**ADDENDUM TO RFP DOCUMENTS**

<b>SOLANO</b> COMMUNITY COLLEGE 	ADDENDUM #01
	Project: #16-015 Solano Community College District Site Lighting Improvements Project
	Date: March 29, 2016

**ITEM NO. 1 – PLAN SHEET 0.00 – COVER SHEET, INDEX**

PV POLE LOCATIONS  
ALTERNATE #3

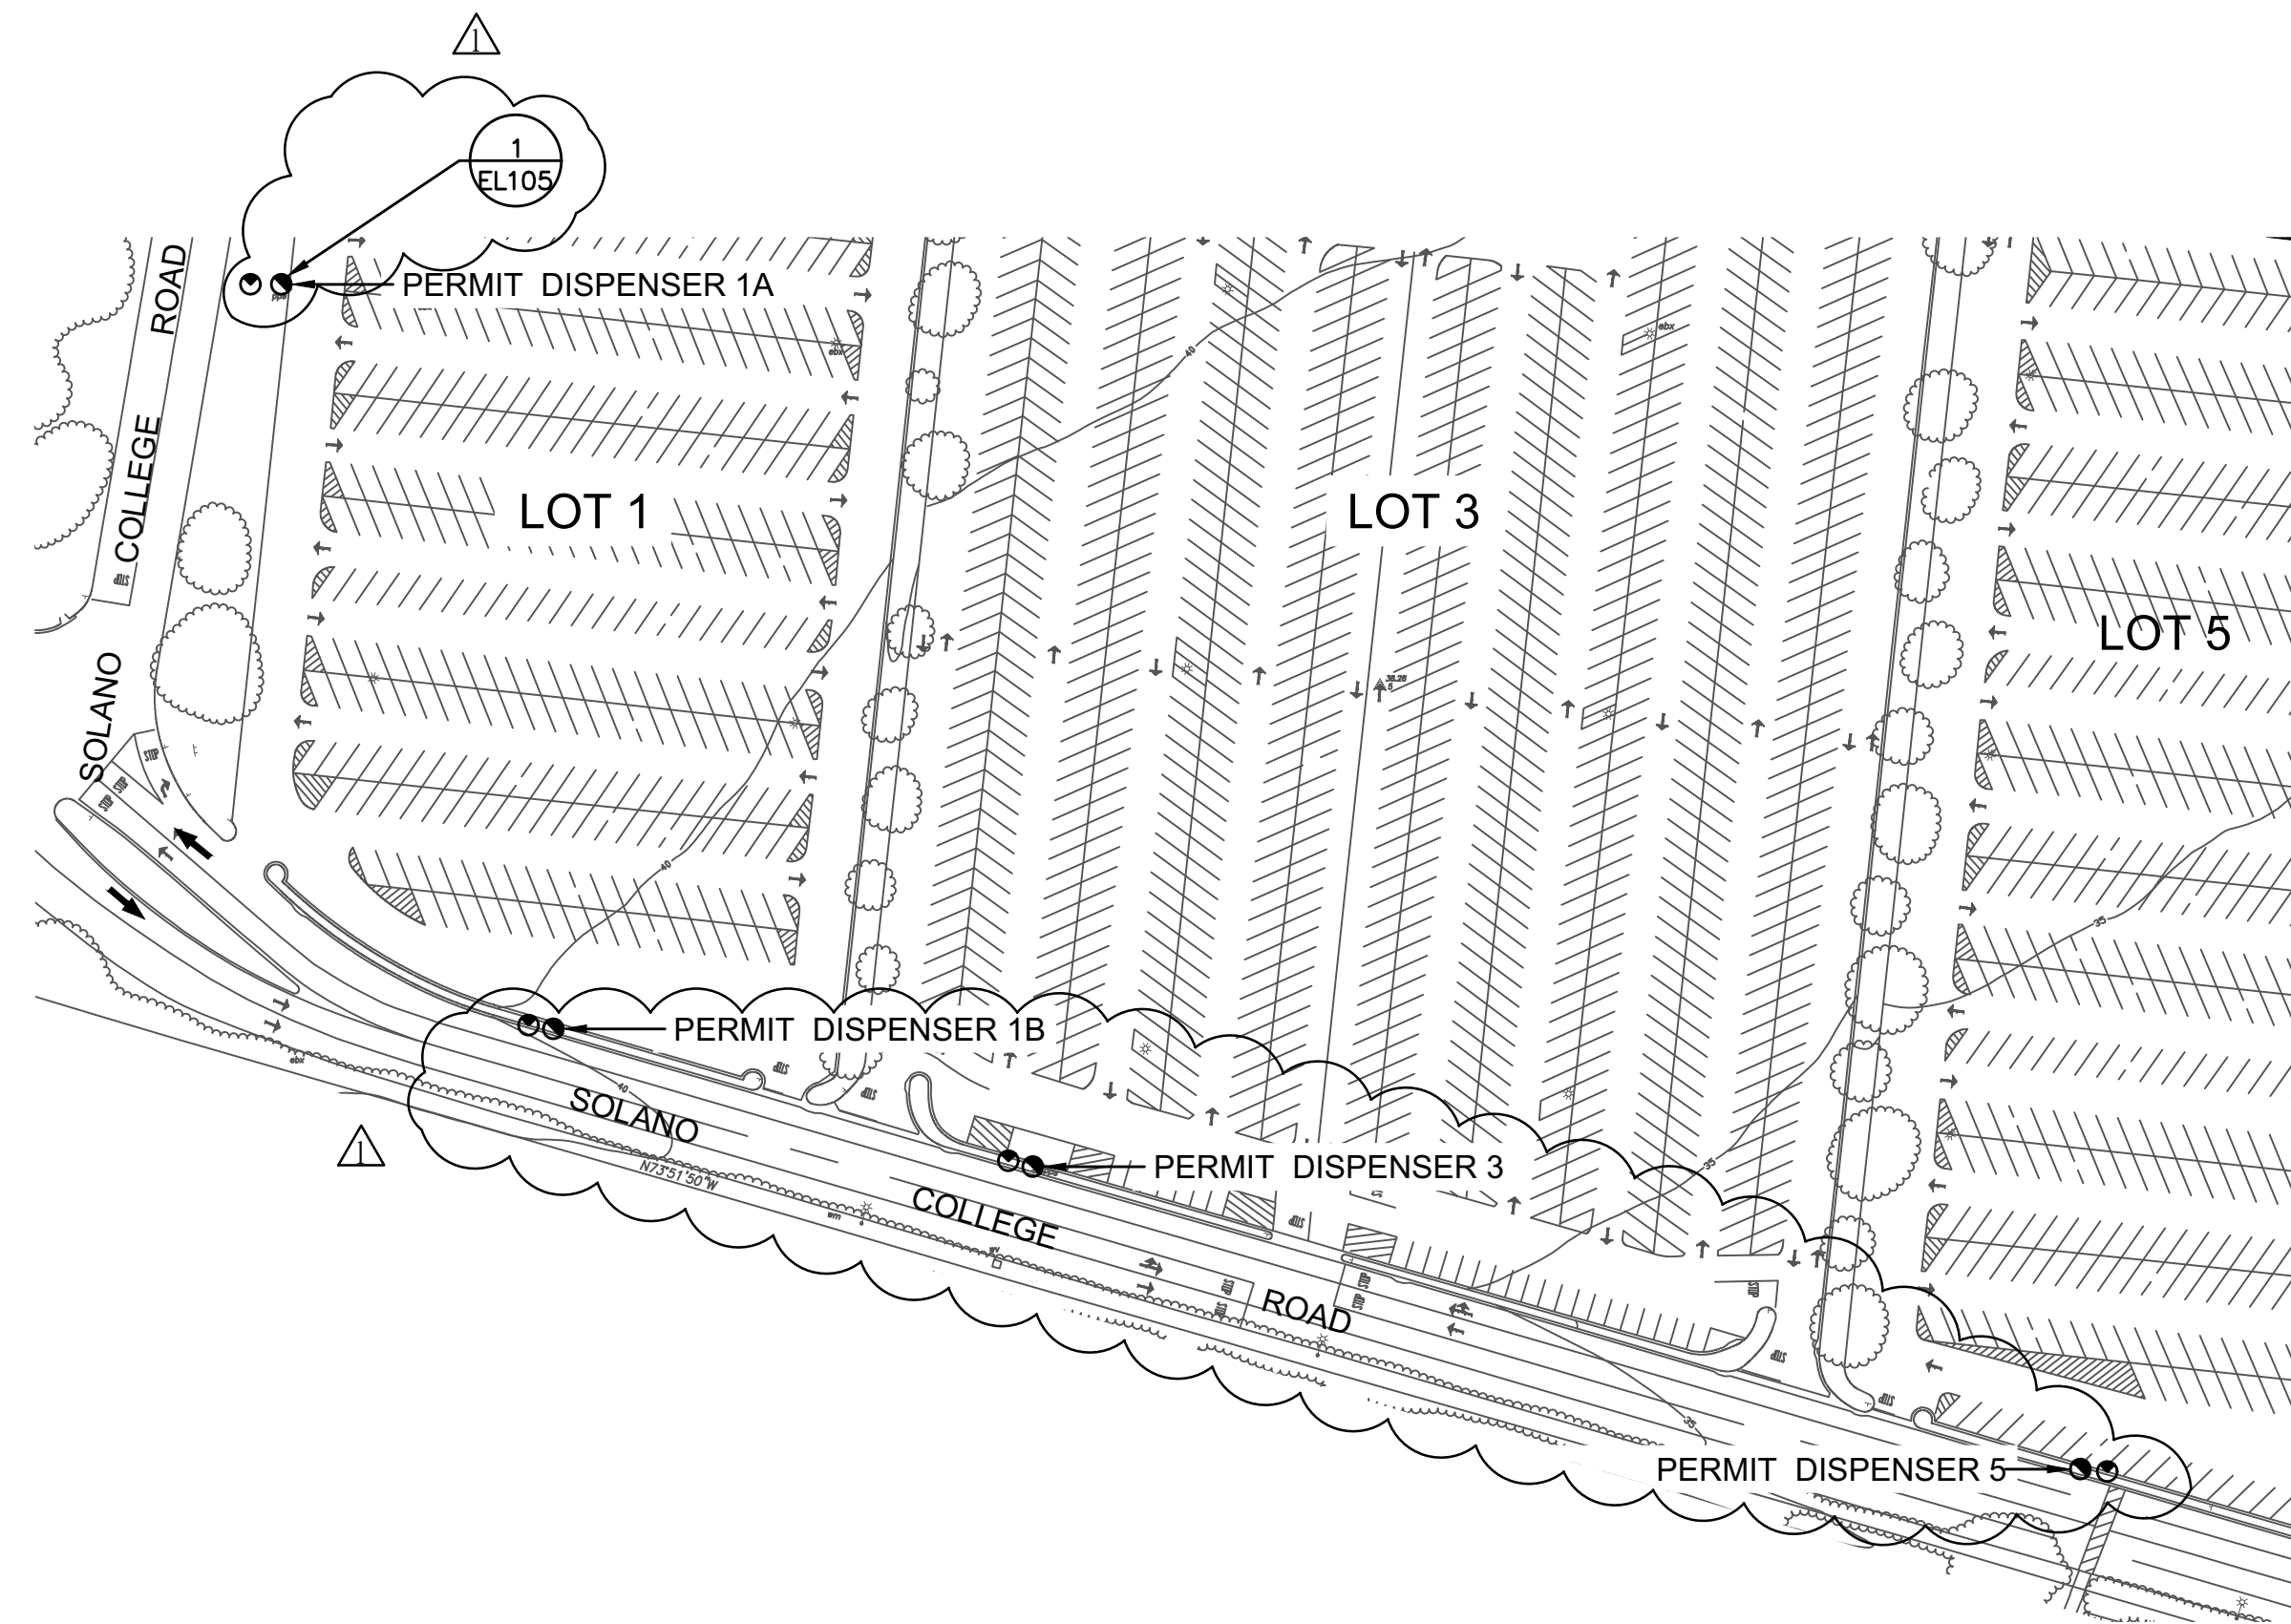
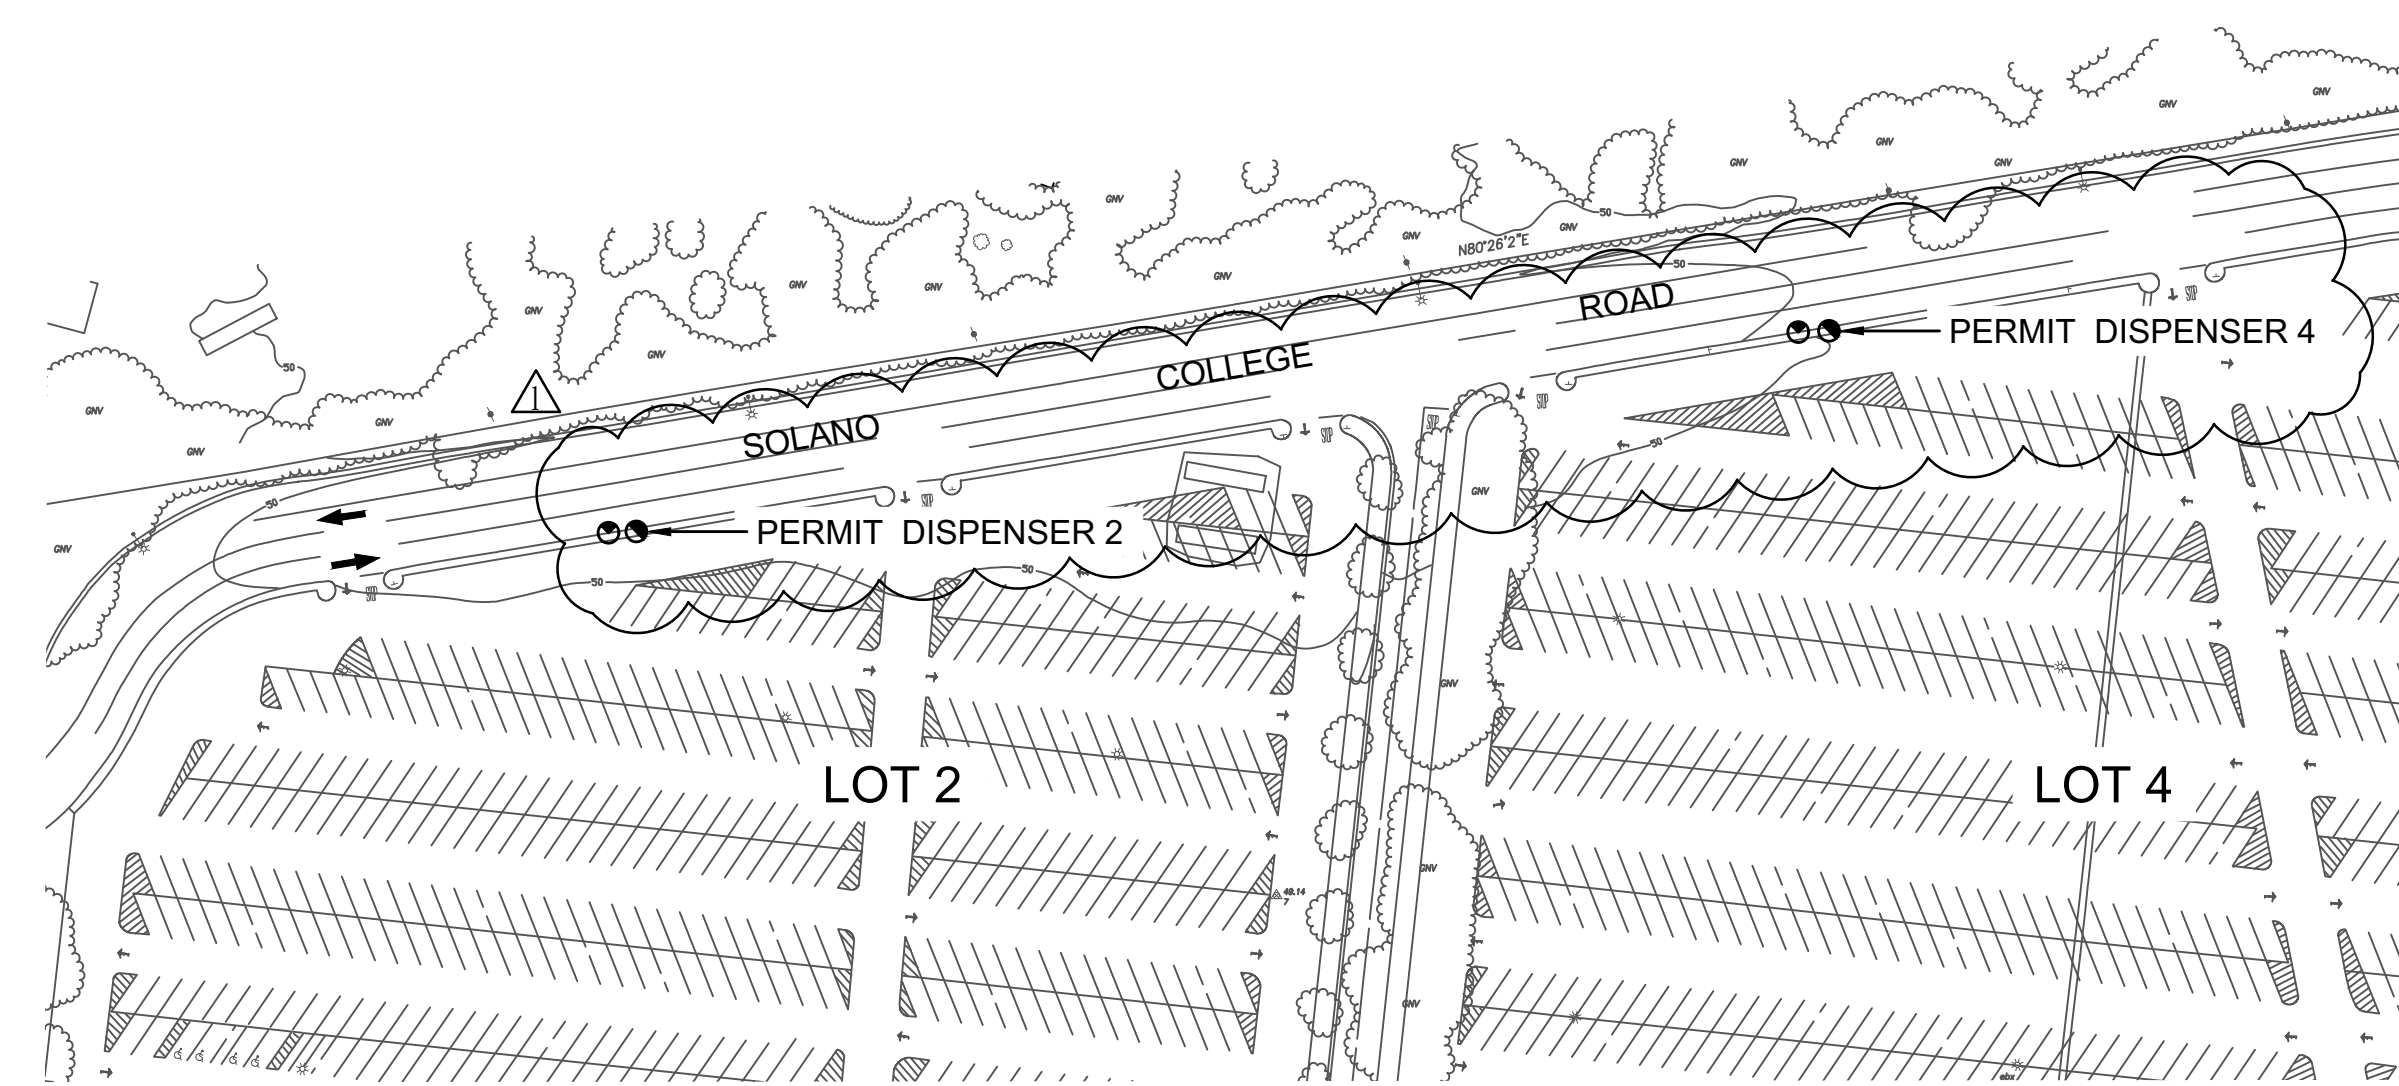
**ITEM NO. 6 – PLAN SHEET EL 104 – PV POLE LIGHT LOCATIONS (ALTERNATE #3)**

Include the attached 'Plan Sheet EL 104 – PV POLE LIGHT LOCATIONS (ALTERNATE #3)' into Contract Bid Documents. Added sheet identifies 'Alternate #3', to include:

- Furnishing and installation of six (6) standalone photovoltaic lights for parking permit dispensers, including pole/standard, footing/base support, solar power assembly and associated hardware.
- Scope of work for photovoltaic lights shall include all materials, labor and testing for a complete and fully operational system.
